Addendum 148 – UN Regulation No. 149

Amendment 3

Supplement 3 to the original version of the Regulation – Date of entry into force:
30 September 2021

Uniform provisions concerning the approval of road illumination devices (lamps) and systems for power-driven vehicles

"Figure A4-IX

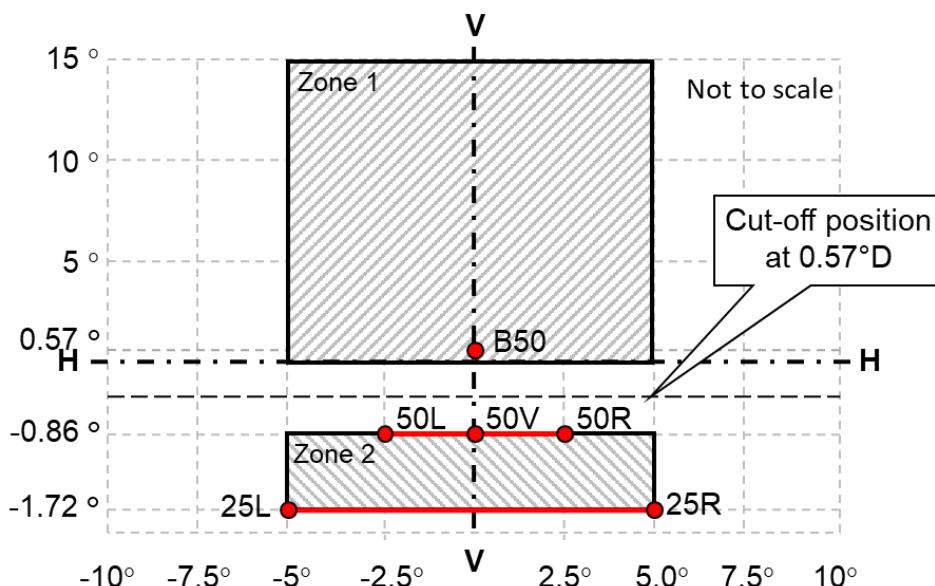
Figure A4-IX; amend to read:

Passing beam test points and zones for Class BS headlamp(s)

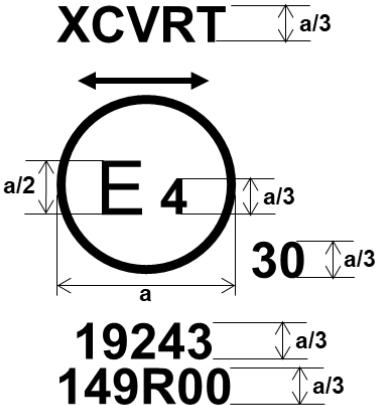
Paragraph 2.1.2.2.1. (a) and (b), amend to read:

(b) Passing-beam, for AFS system:

Class C passing beam and each specified other passing beam class:

50V, B50L and 25LL, if applicable"

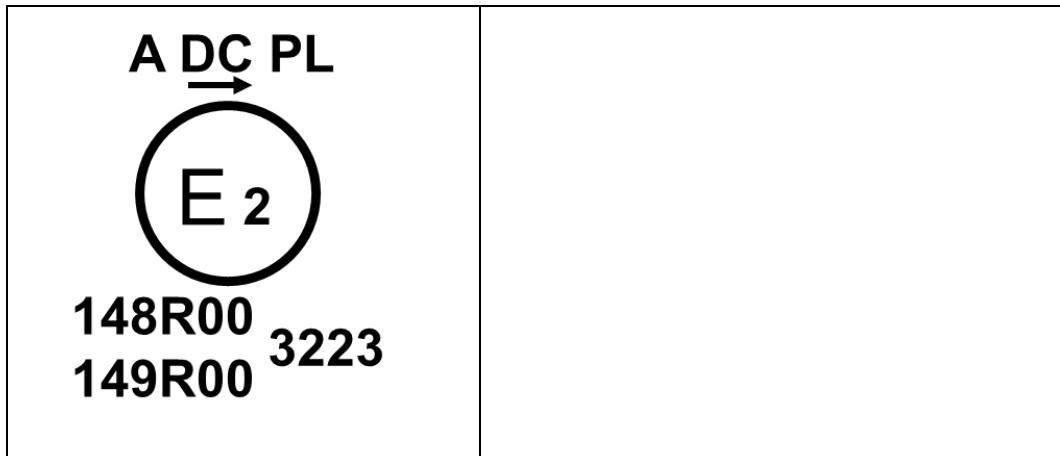
Annex 13, amend to read:

<p>Figure A13-I - Marking example 1</p>  <p>a = see para. 3.3.1.2.1. of this Regulation</p>	<p>The device bearing the approval mark shown on the left is an installation unit of an AFS approved in the Netherlands (E4) under approval number 19243 pursuant to this Regulation.</p> <p>The number after 149R indicates that approval was granted in accordance with the requirements of this Regulation in its original form (00).</p> <p>The functions identification symbols show that the approval was granted in respect of the driving-beam (R) and the Class C and Class V passing-beam. The double pointed arrow shows that the passing beam is suitable for both traffic systems by means of an appropriate adjustment of the setting of the optical element or the light source on the vehicle. Class C passing-beam, Class V passing-beam and driving-beam comply to bending lighting provisions, as indicated by the letter "T". The score above the letter "R" indicates that the driving-beam function is provided by more than one installation unit on that side of the system.</p> <p>Number 30 indicates that the maximum luminous intensity of the driving-beam is between 123,625 and 145,125 candelas.</p>

<p>Figure A13-II - Marking example 2</p>	<p>The lamp bearing the approval mark shown on the left is a gas-discharge passing beam headlamp (DC) for left-hand traffic only (arrow) using a plastic lens (PL) approved in France (E2) pursuant to this Regulation 149R as set in the original series of amendments (00) combined with a front position lamp (A) as set in the original series of amendments (00) of the Regulation on Light Signalling Devices 148R. Both lamps (functions) are approved under approval number 3223.</p>

Figure A13-III
Marking example 3

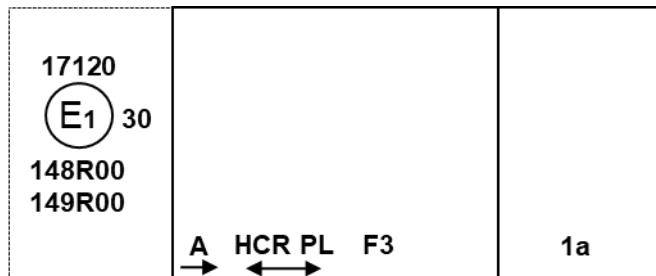
Note: The examples in Figures A13-III and A13-IV correspond to a lighting device bearing an approval mark comprising:

- (a) A front position lamp approved in accordance with the 00 series of amendments to UN Regulation No. 148. The horizontal arrow indicates the side on which the required photometric specifications are met up to an angle of 80° H;
- (b) A headlamp, Class B, with a passing-beam designed for right-hand traffic only and a driving-beam with a maximum intensity comprised between 123,625 and 145,125 candelas (as indicated by the number 30), approved in accordance with the requirements of this Regulation, as amended by the 00 series of amendments and incorporating a lens of plastic material;
- (c) A front fog lamp approved in accordance with the 00 series of amendments of this Regulation and incorporating a lens of plastic material;
- (d) A front direction indicator lamp of category 1a approved in accordance with the 00 series of amendments to UN Regulation No. 148.

Figure A13-V
Marking example 4-b

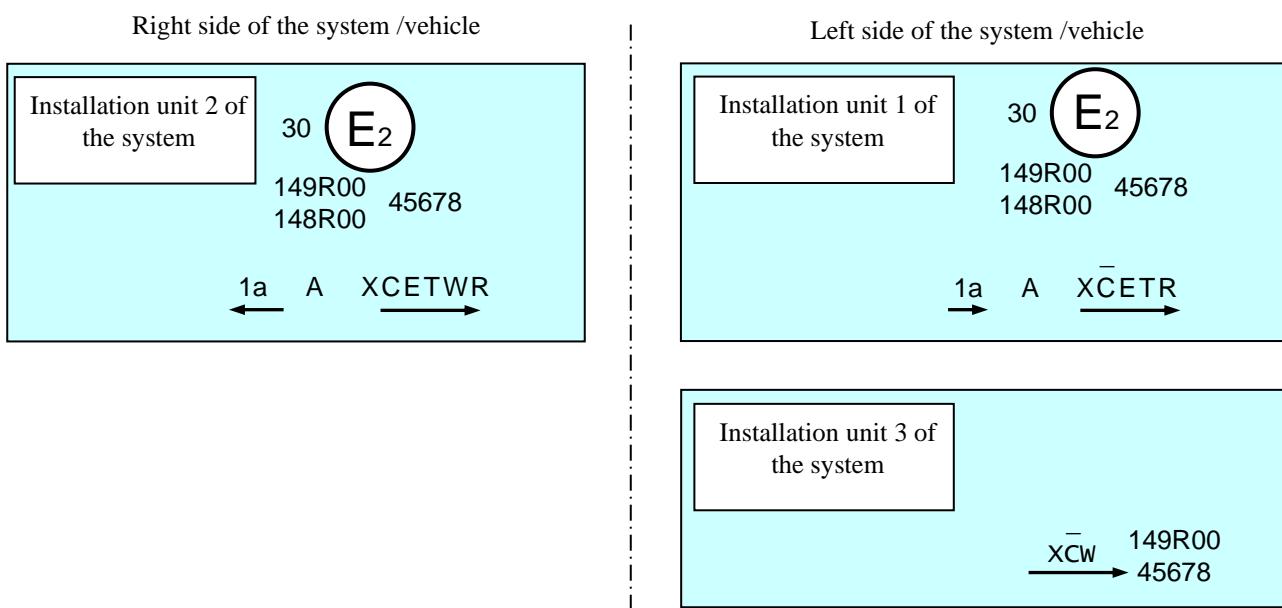
This example corresponds to an adaptive front-lighting system composed of two installation units for the left side of the vehicle and one installation unit for the right side.

The system bearing the above approval marks meets the requirements of this Regulation (original version of the Regulation) in respect of both a passing-beam for left-hand traffic and a driving-beam with a maximum intensity comprised between 123,625 and 145,125 candelas (as indicated by the number 30) grouped with a front direction indicator lamp of category 1a and a front position lamp approved in accordance with the 00 series of amendments of UN Regulation No. 148.

The installation unit 1 of the system (left side) is designed to contribute to the Class C passing-beam and the Class E passing-beam. The score above the letter "C" indicates that on that side more than one installation unit contributes to the Class C passing-beam. The letter "T" to the right following the listed symbols indicates that each, the Class C passing-beam and the Class E passing-beam are providing a bending mode.

The installation unit 3 of the system (left side) is designed to provide the second part of the Class C passing-beam of that side (as indicated by the score above the letter "C") and a Class W passing-beam. For this additional lighting unit, a circle surrounding the letter "E" followed by the distinguishing number of the country is not necessary.

The installation unit 2 of the system (right side) is designed to contribute to the Class C passing-beam, a Class E passing-beam, both with bending mode and a Class W passing-beam.

Note: In the above example, the different installation units of the system shall bear the same approval number.
